**Brighton
Council**

Your Ref: DA 2025/095
Our Ref: 25.133

PLANNING APPLICATION DA 2025/00095 – RESPONSE TO REQUEST FOR ADDITIONAL INFORMATION

PROJECT: CONCRETE BATCHING PLANT
AT: 1 / 13 CROOKED BILLET DRIVE
BRIDGEWATER
FOR: HAZELL BROS GROUP PTY LTD

DRAWING: CIVIL WORKS
SAMPLE TURN PATHS
SHEET 2.

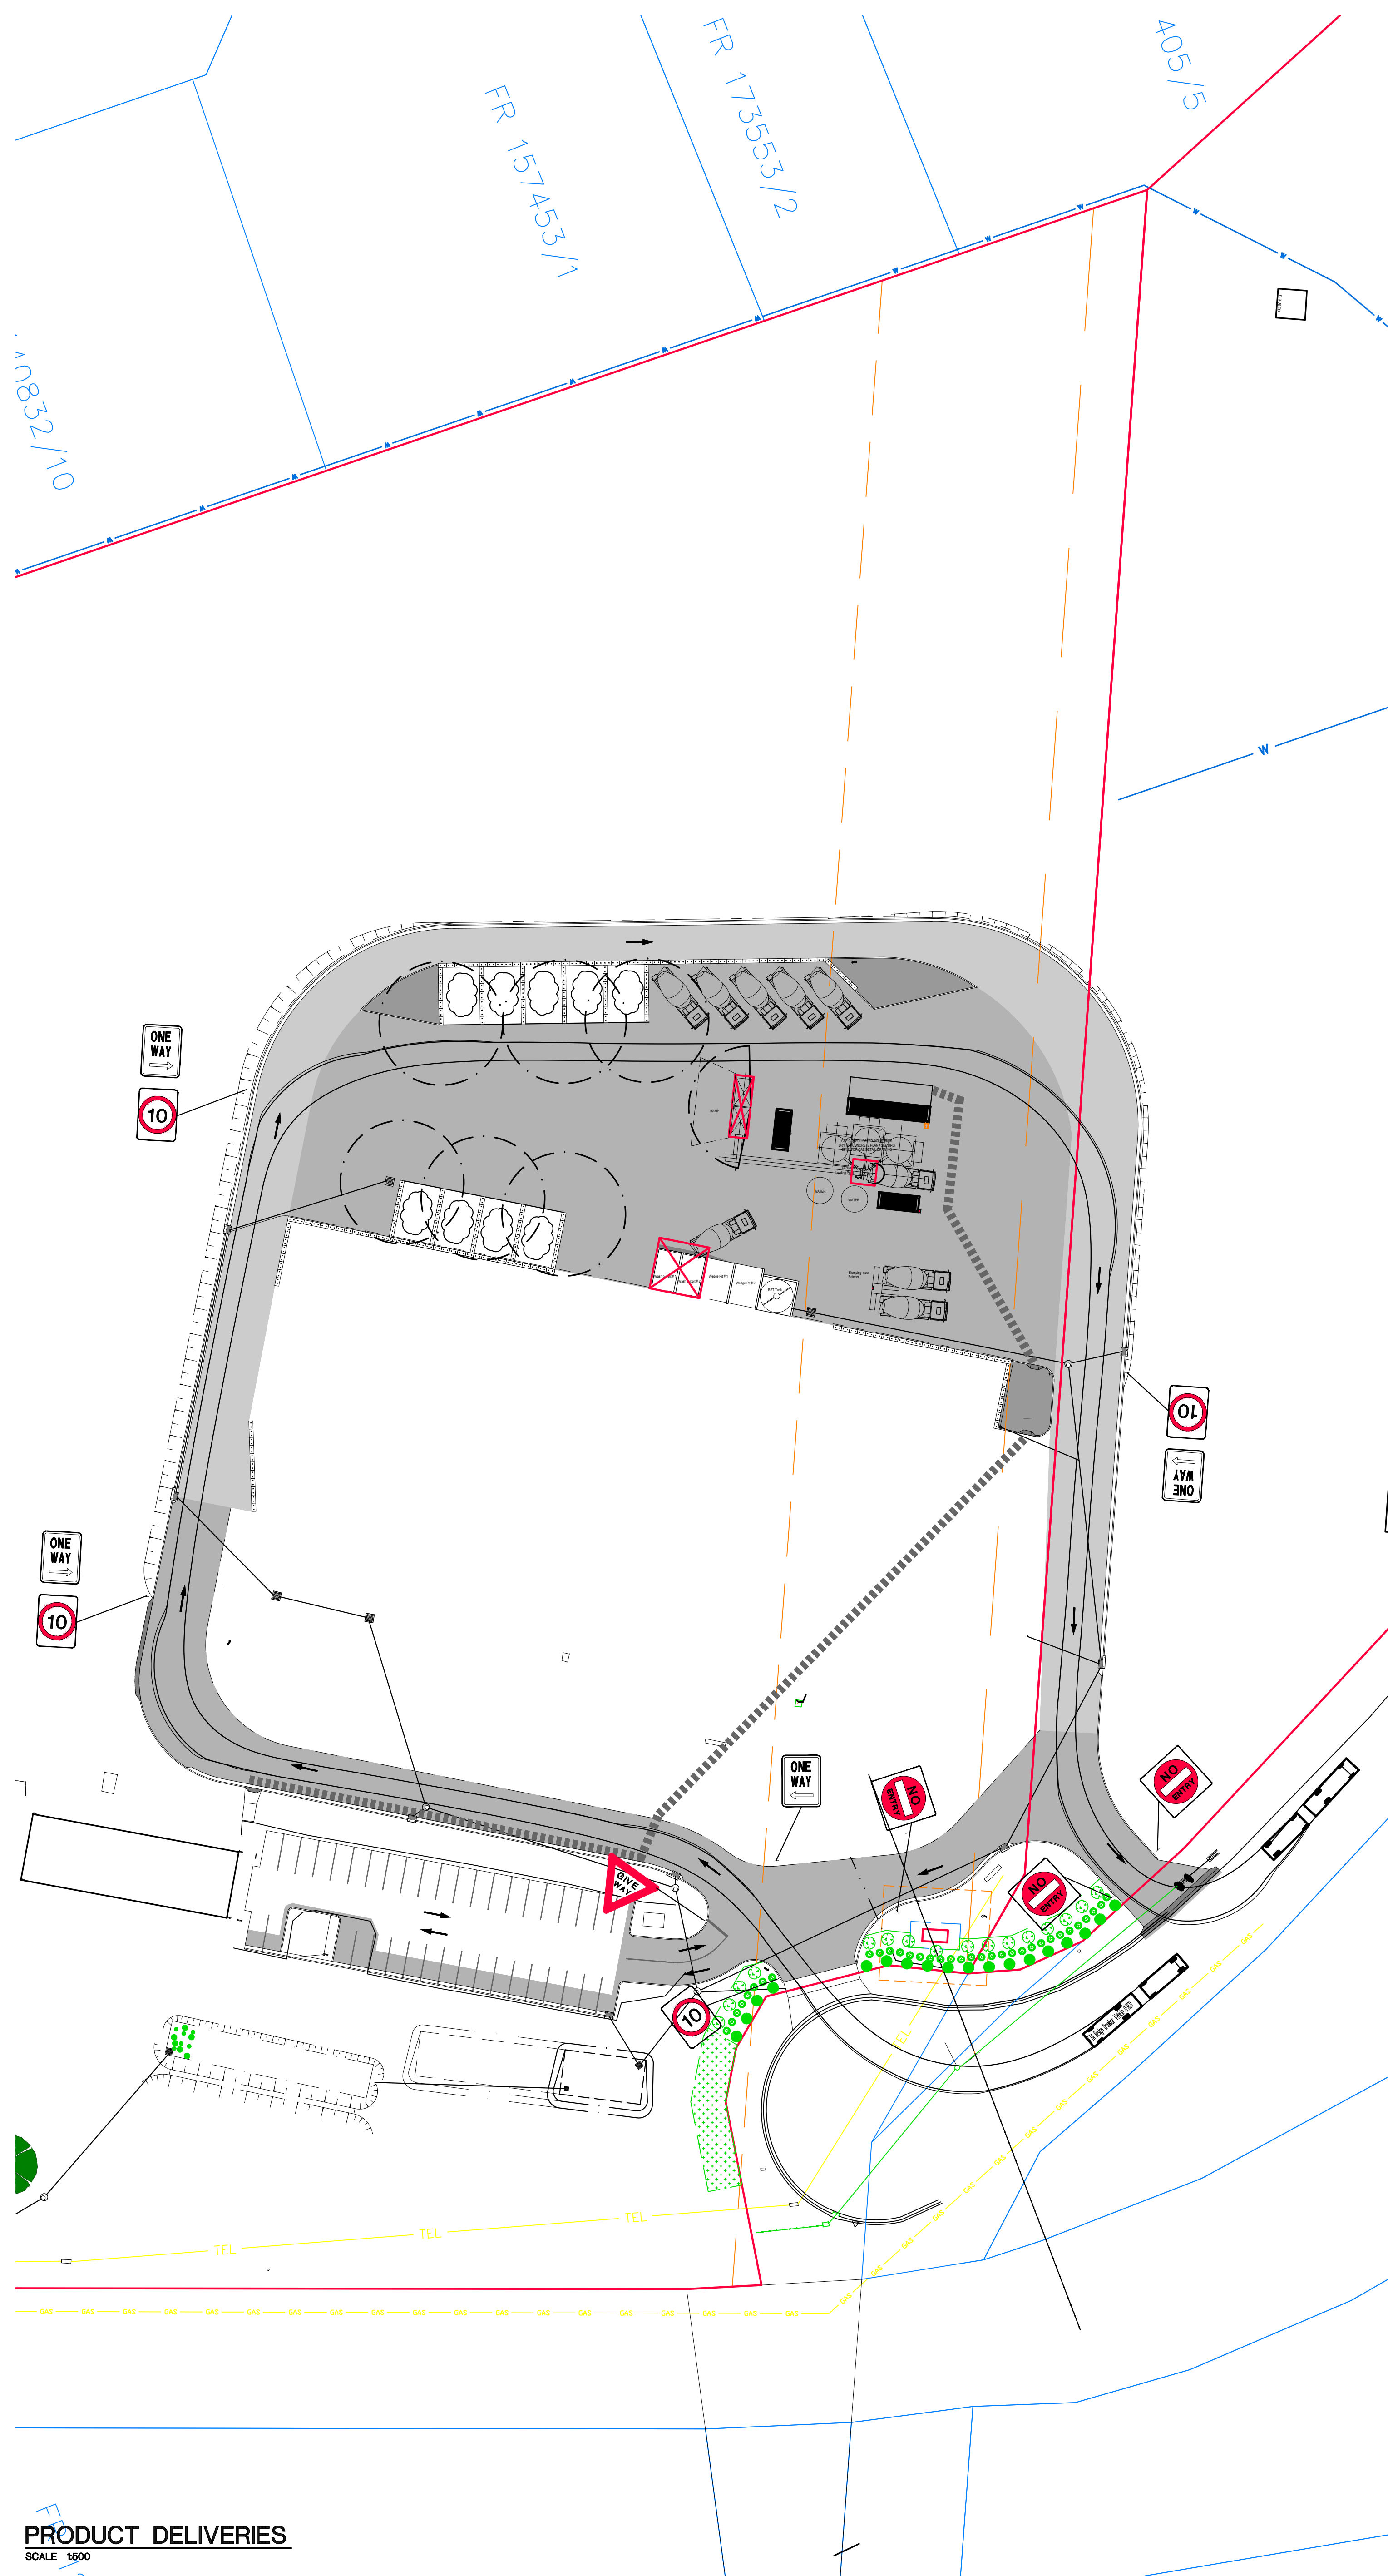
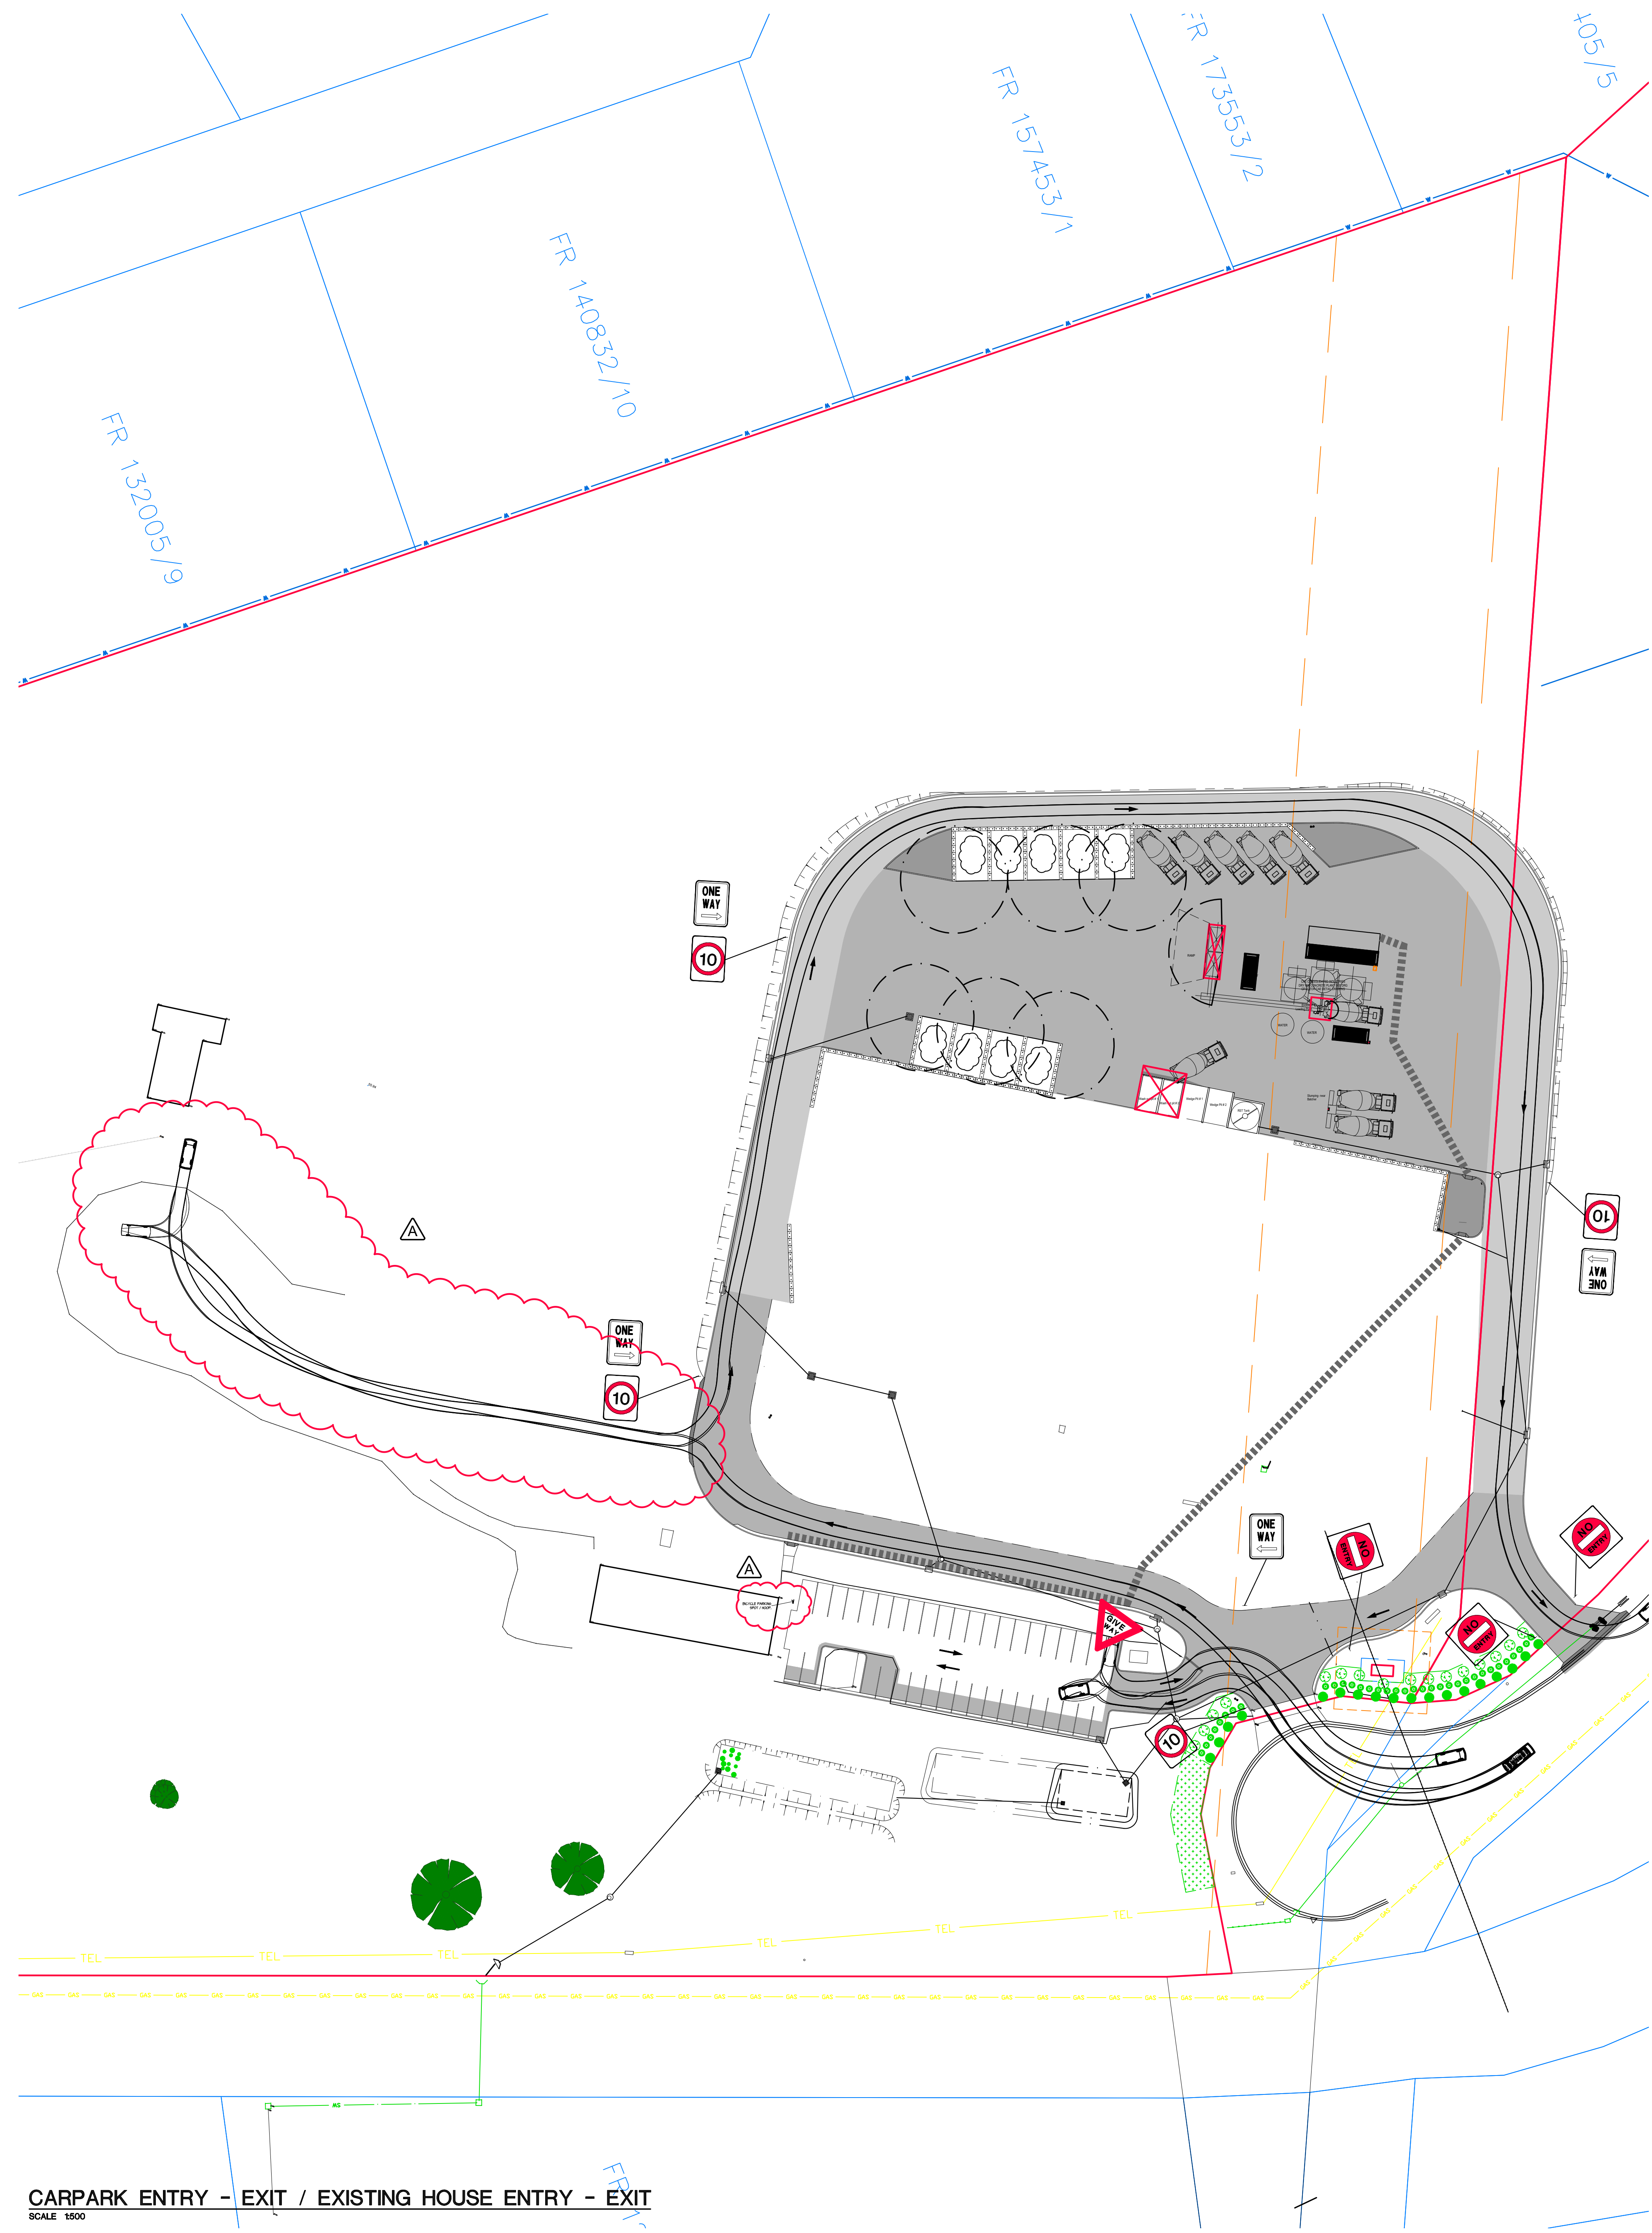
- The following relevant documents accompany this response:
 - Sample Turn Paths Sheet 2, Prepared by 6ty°, Drawing No. CP19, Revision A, Dated 25 July 2025; and
 - Amended Traffic Impact Statement (TIS), Prepared by Traffic & Civil Services, dated 1 August 2025.

The amended plan shows a bicycle parking space as required by the acceptable solution for the relevant code standard. The amended TIS references the location of this parking space.

- The amended Sample Turn Paths Sheet 2 considers the circulation of vehicles associated with the existing dwelling through the site, and this is reflected in the amended TIS.
